Application ref: EN010147

Application by Photovolt Development Partners (PVDP) on behalf of SolarFive Ltd (the Applicant) for a Development Consent Order for Botley West Solar Farm

Notification of Intention to Submit a Request to Change the Application (Change Request 2)

Notification - Change 7

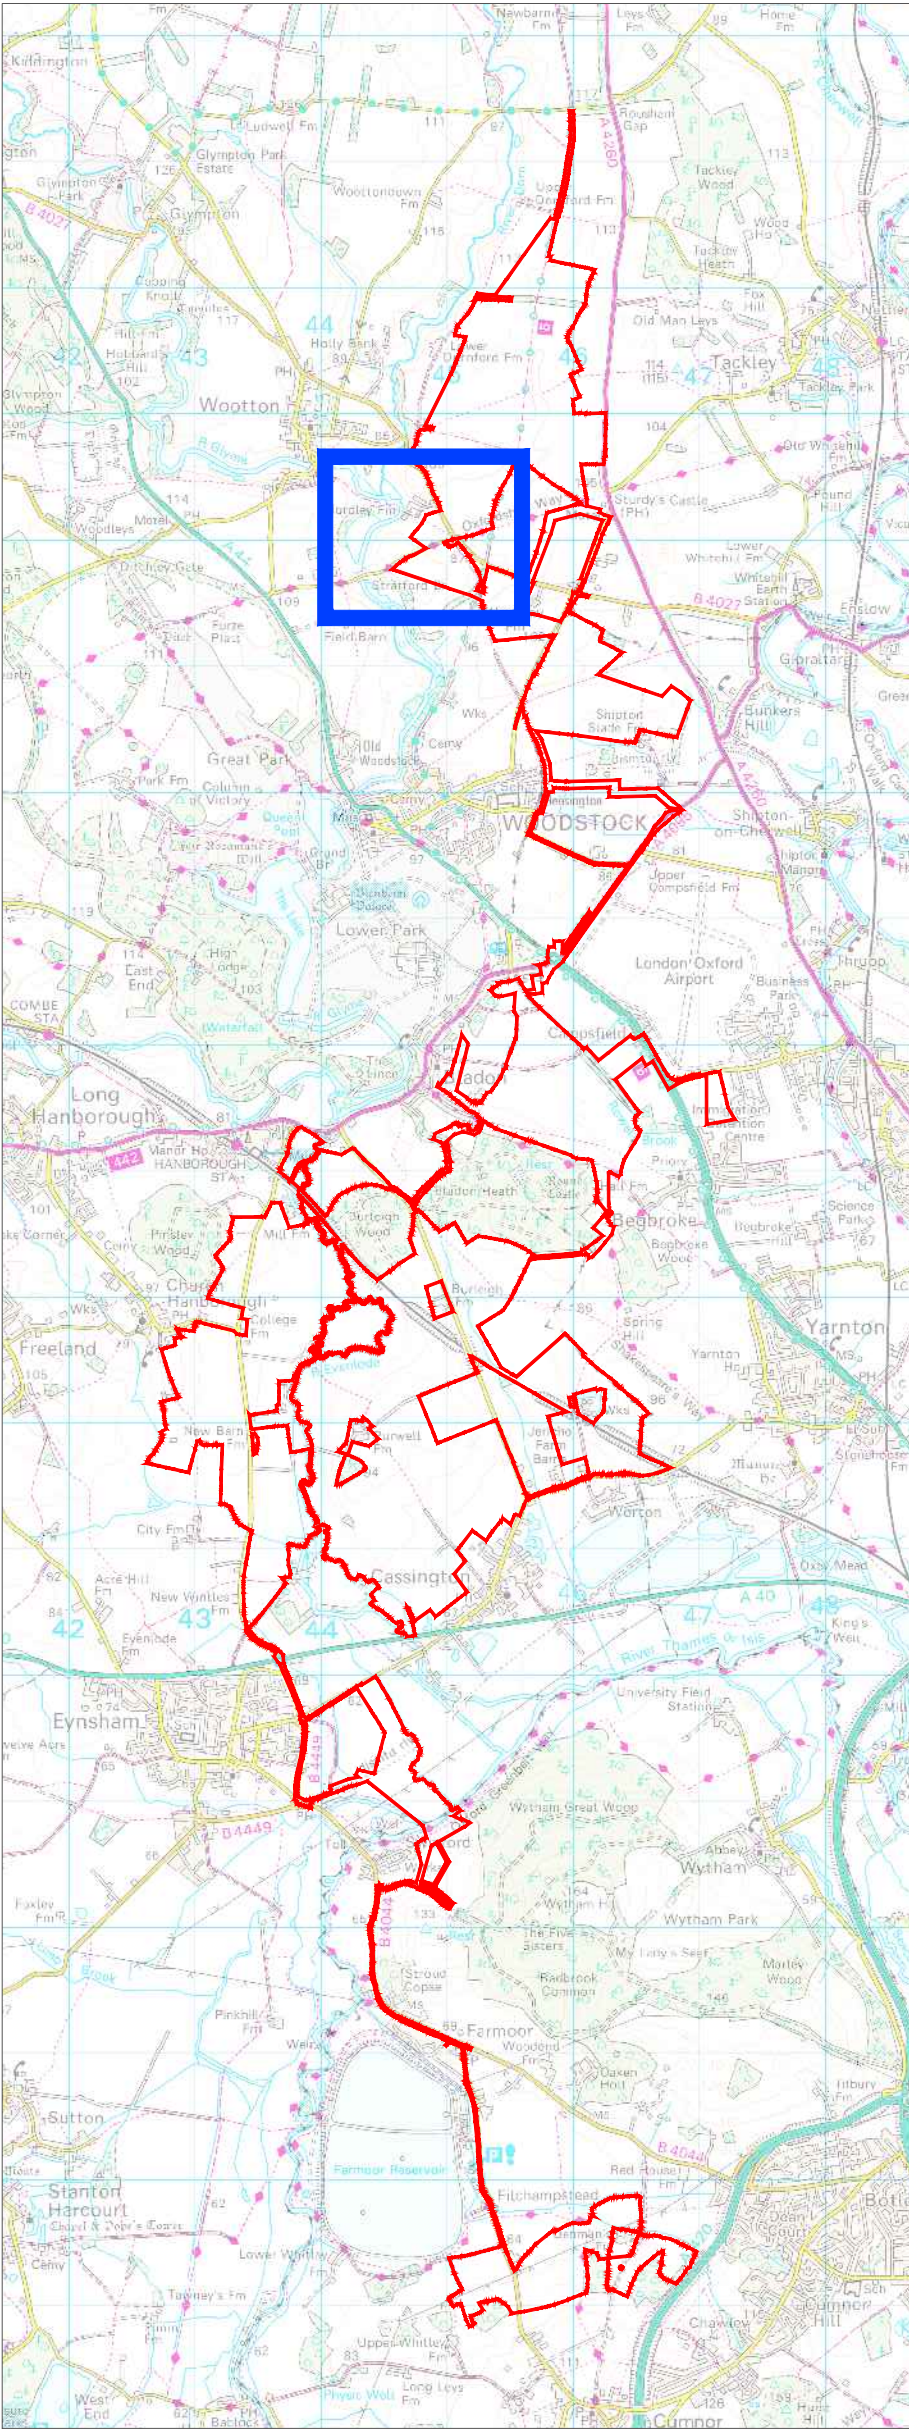
Change 7: Reduction in Order Limits boundary to remove small parcels of land owned by Oxfordshire County Council (Estates) (see Appendix A attached to the Notification)

This change is sought to refine the Order Limits so that these sections of the Order Limits only include the extent of the public highway (i.e. land of Oxfordshire County Council in its capacity as highway authority) and do not involve land owned by Oxfordshire County Council in its 'Estates' capacity. The amount of land proposed to be removed is approximately 0.005ha only.

(1), (2) and (3) Refinement of Redline

Title
Change Request 2
Notification - Change 8

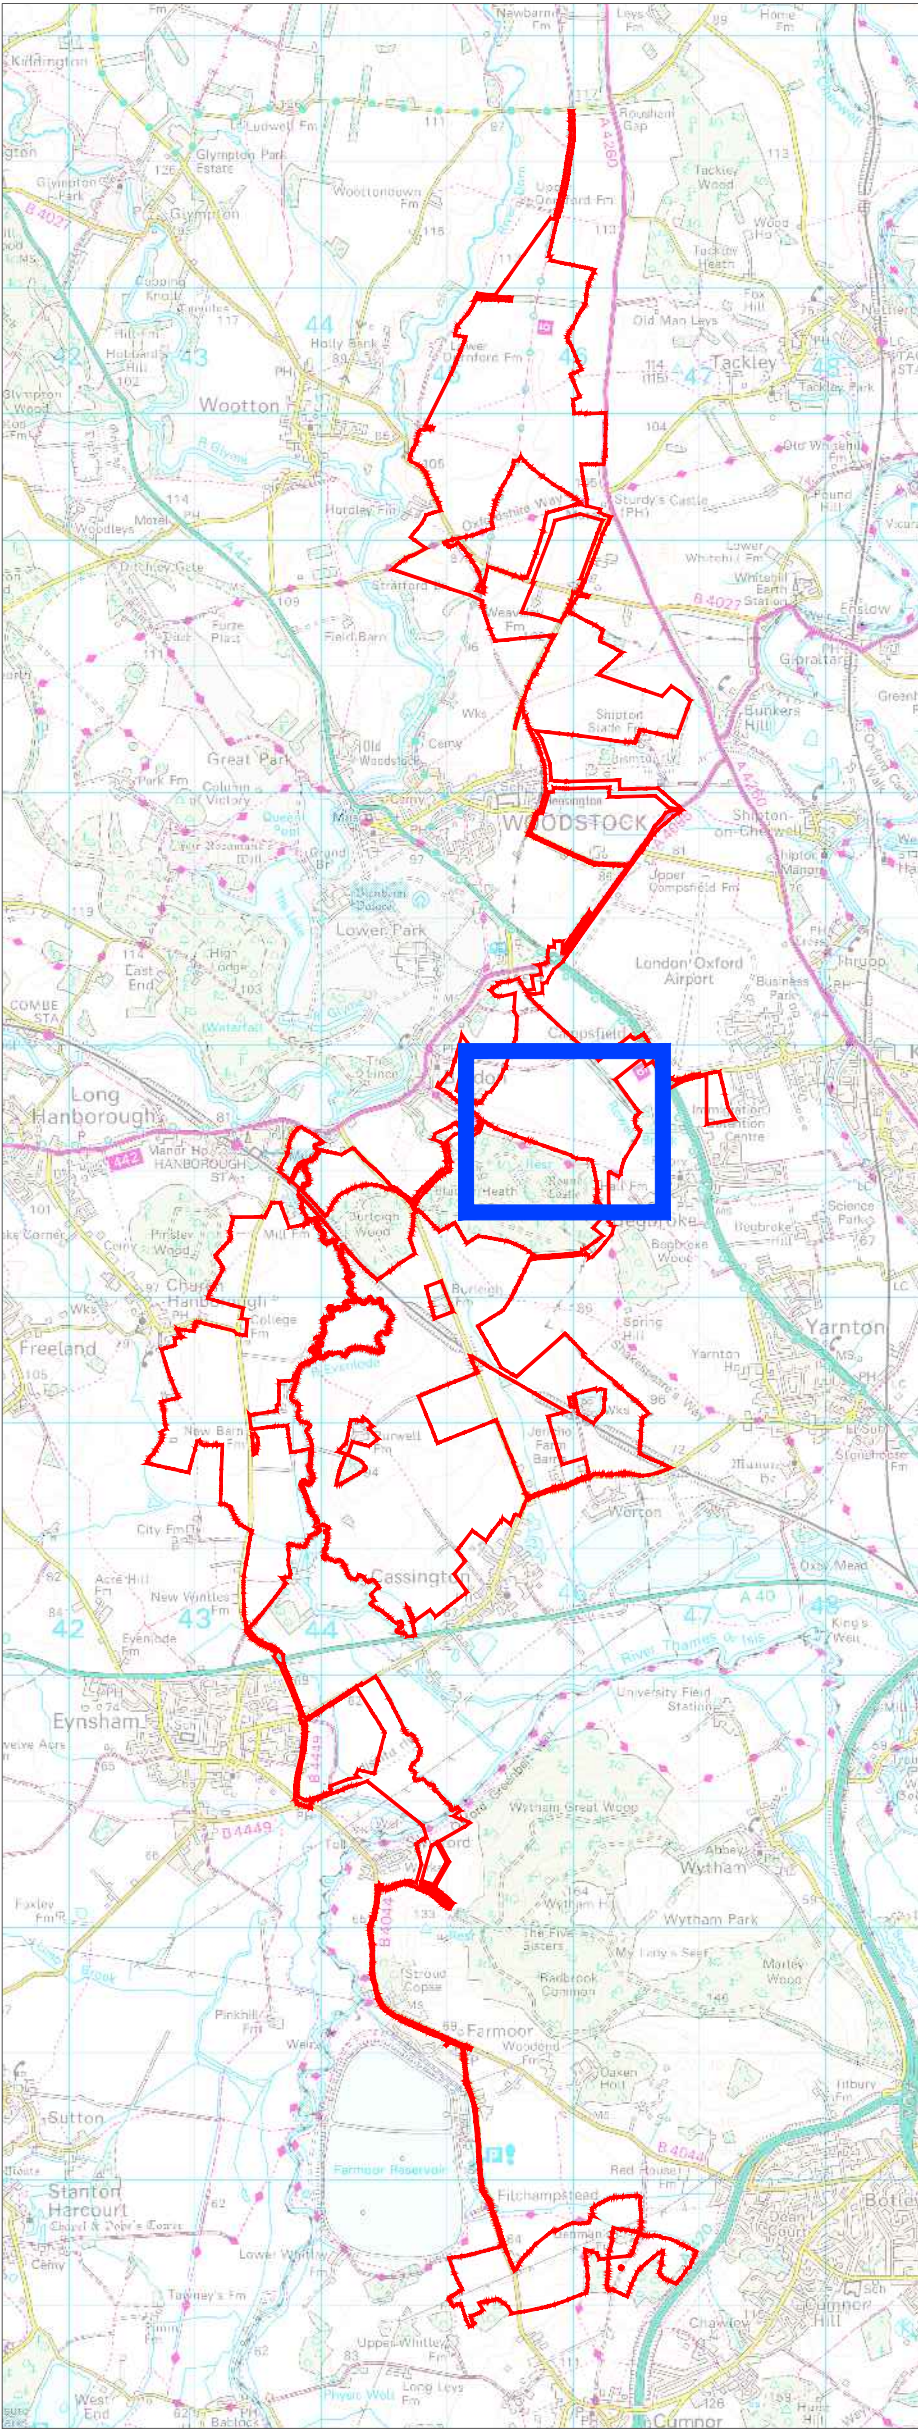
Change 8: Refinement of Project layout and design to reposition the Public Rights of Way currently proposed to be stopped up and diverted back to definitive alignment - (see Appendix A attached to the Notification)

Prior to submission of the Applicant's DCO Application, the Applicant became aware that there was a difference between the aerial data showing the used footpath routes on the ground and the Oxfordshire County Council (OCC) definitive data set of their alignment. The data showed that the routes used by the public deviated from the definitive data set alignment. The Applicant therefore sought powers to alter the alignment of the PRoW to reflect the 'desire lines' on the ground. However, following ongoing discussions with OCC, the Applicant is seeking to remove those powers to adopt the OCC definitive alignments which will result in a change to the submitted plans.

- Project Refinements
- (1) Addition of Solar Installation Area after PROW Adjustment (0.17ha) 
- (2) Removal of solar installation area, fence, maintenance roads and gates for PROW adjustment (0.08ha).
